# Type 1 Power Parameter Adjustments v1

This presentation proposes increasing Type 1 MPD 1U power to 4W and details the changes needed to power parameters

Table 189-1—System power types

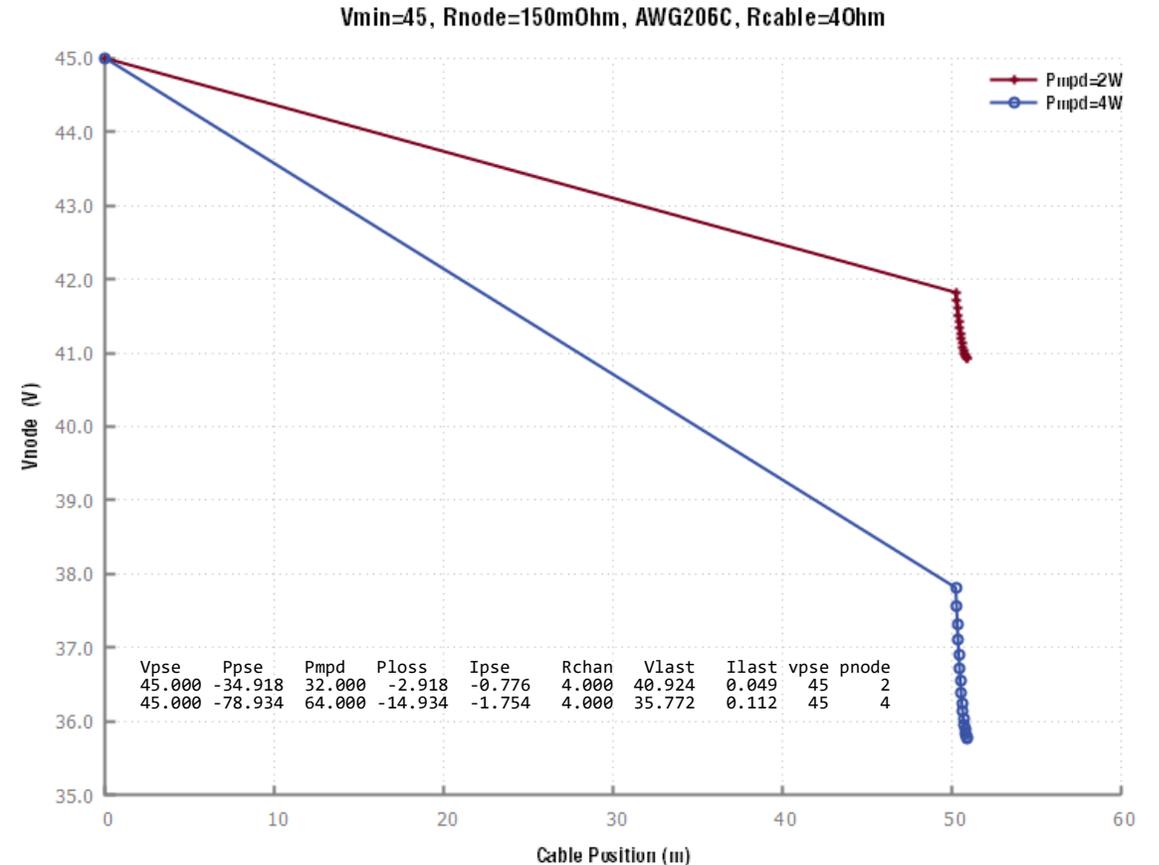
Adjust power parameters while keeping last node voltage above ~35V

30 V Max MPSE (Type 0)	50 V Max MPSE (Type 1)	Units
V <sub>MPSE</sub> max	30	50	V
V <sub>MPSE</sub> min	21.6	45	V
V <sub>MPD</sub> min	16	<del>34</del> 35.5	V
I <sub>MPSE</sub> min	1100	<del>1000</del> 1760	mA
P <sub>MPSE</sub> min	23.76	<del>45</del> 79.2	W
P <sub>MPD_IU</sub> max	1.1	<del>2</del> 4	W

Edits Satisfy D2.2 Comments:  
52, 53, 59
